ADDENDUM 5

DATE: December 27, 2017

Contract 17-C-00039; Breckenridge Pumping Station Rehabilitation

SHEET
5

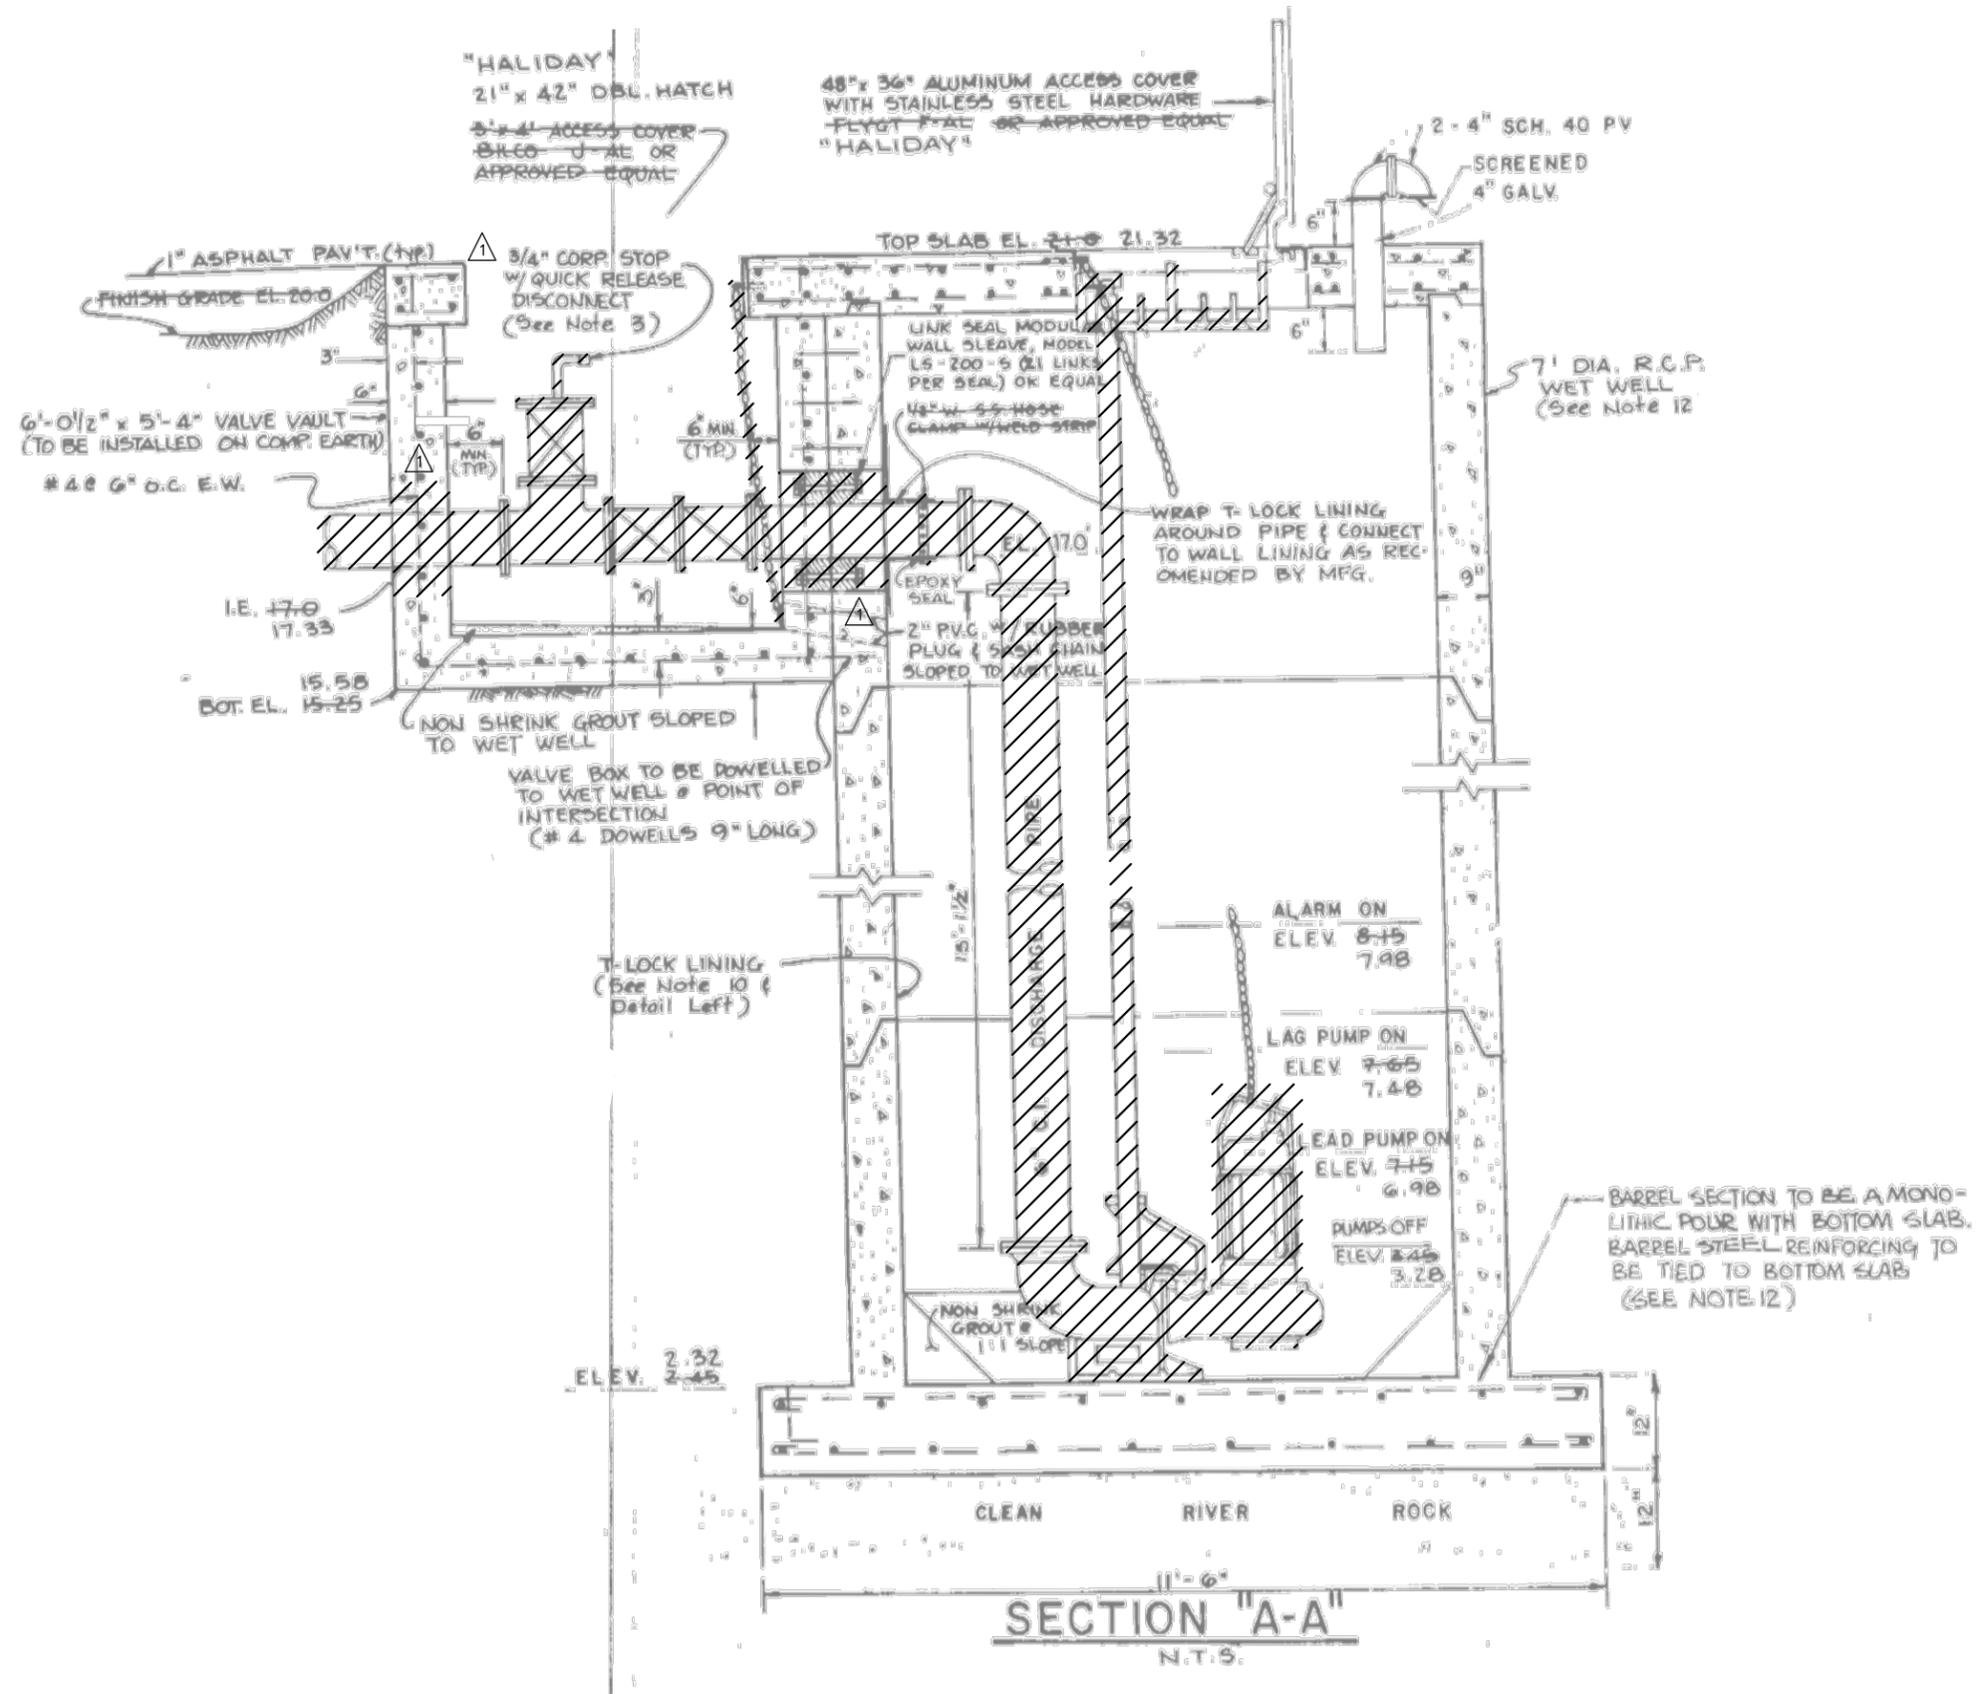
No.	DATE	REVISIONS
3		
2		
1	11/7/2017	REMOVED HATCHING

SHEET
8

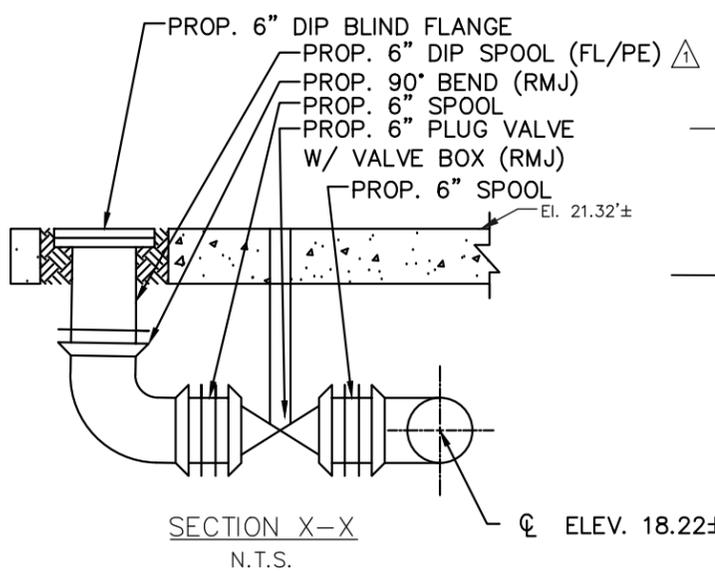
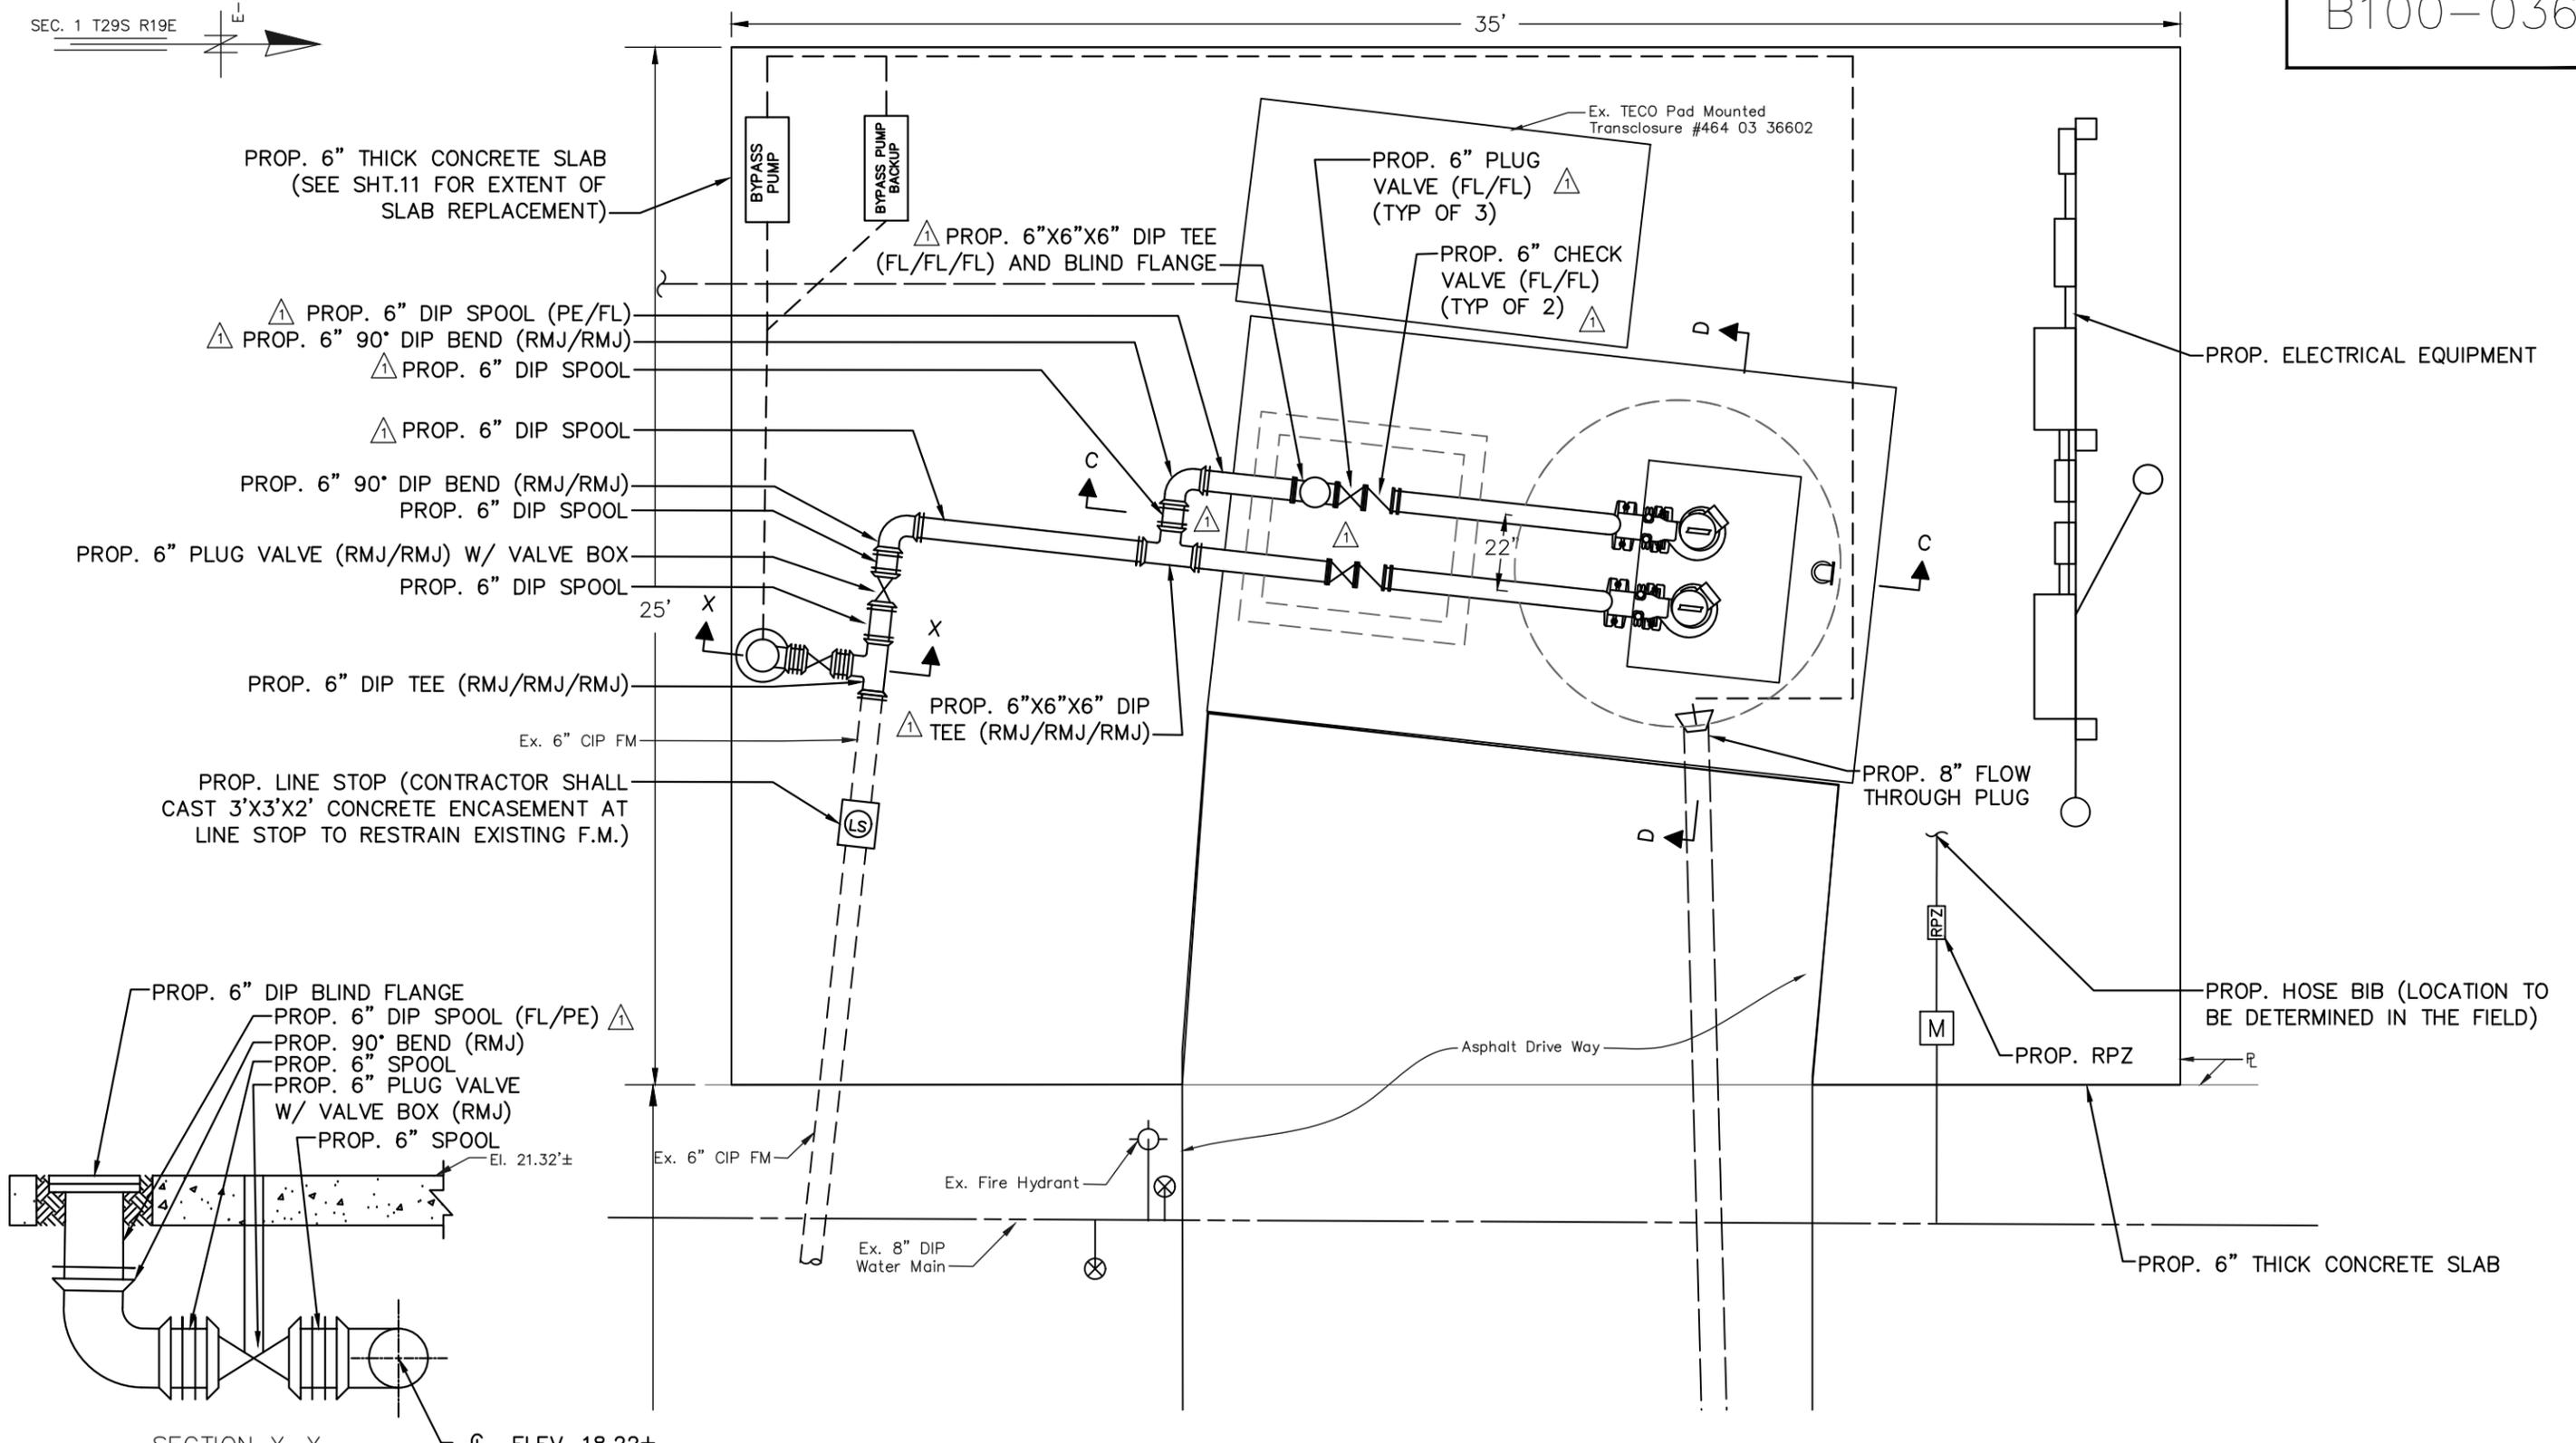
No.	DATE	REVISIONS
3		
2		
1	11/7/2017	VARIOUS CHANGES FROM MOVING VALVES INTO VALVE VAULT

NOTE: CONTRACTOR SHALL RESTRAIN ALL JOINTS FROM VALVE VAULT TO PROPOSED LINE-STOP

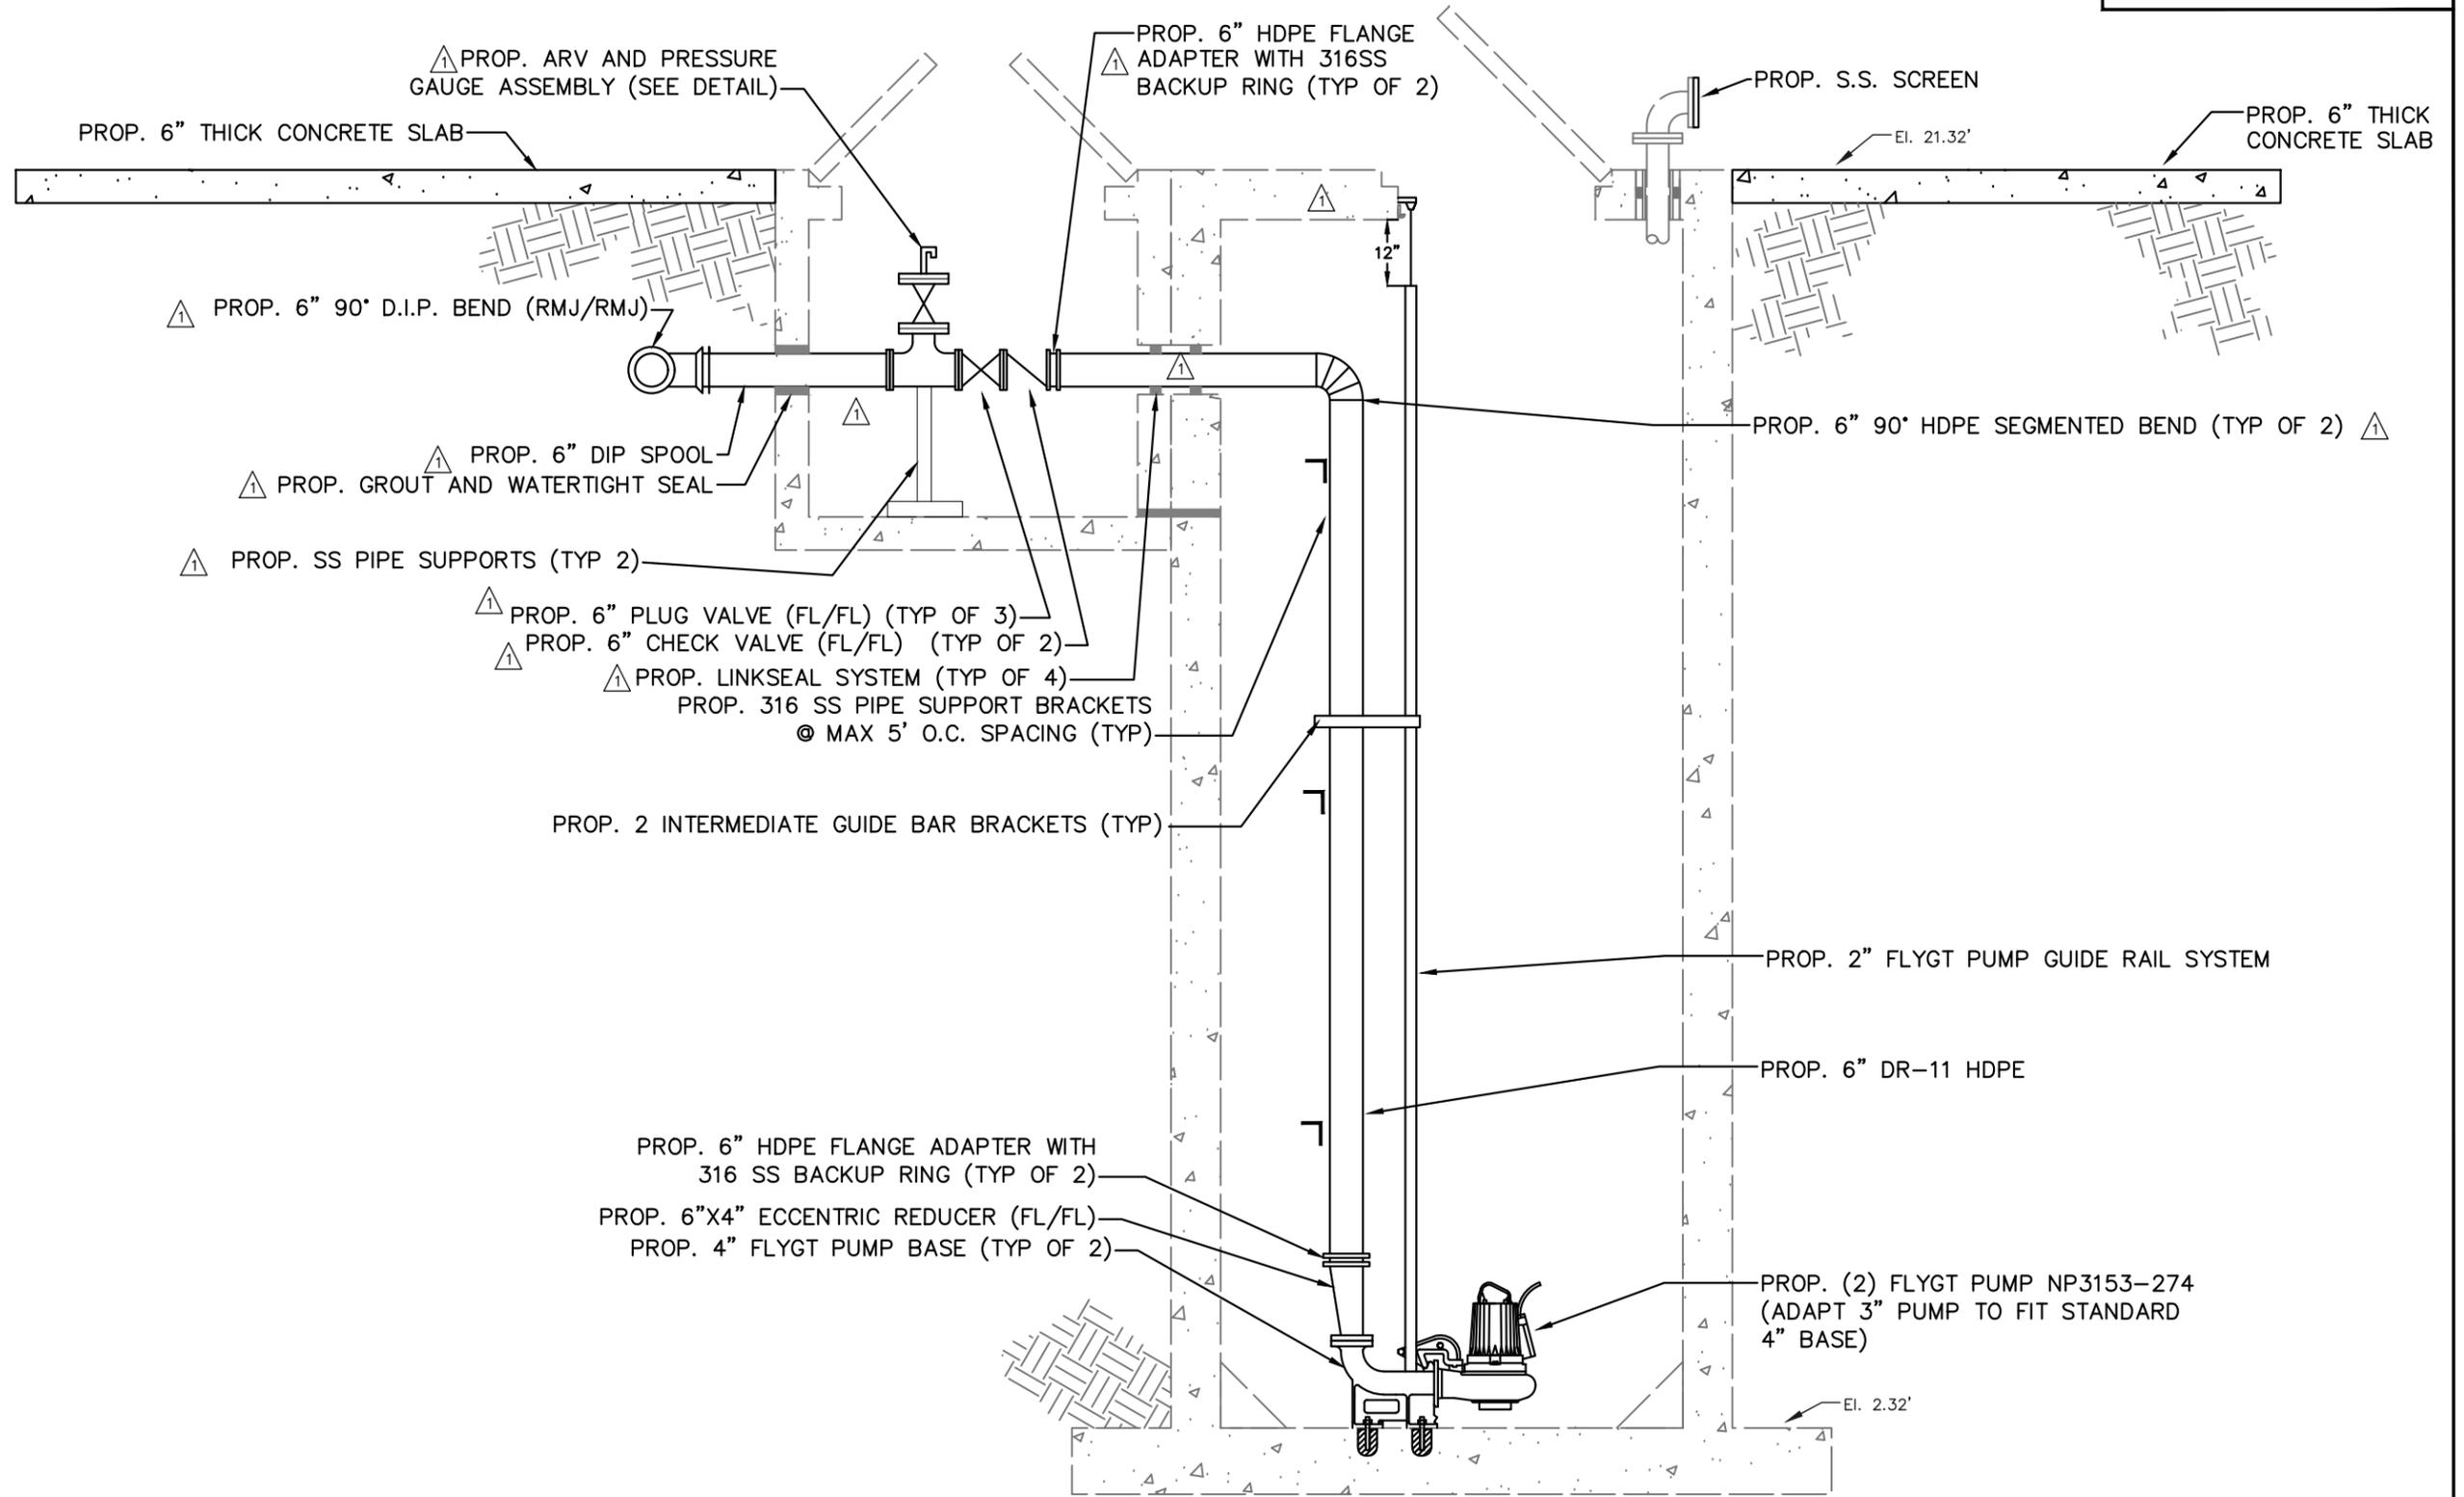
JACINTO CARLOS FERRAS, P.E. #49454 DESIGN DIVISION HEAD WASTEWATER DEPARTMENT	No.	DATE	REVISIONS	DES: VT	CITY of TAMPA WASTEWATER DEPARTMENT	BRECKENRIDGE PUMPING STATION REHABILITATION	SHEET 9
	3			DRN: MRL			
	2			CKD:		PROPOSED SECTION C-C	
	1	11/7/2017	VARIOUS CHANGES FROM MOVING VALVES INTO VALVE VAULT	DATE:
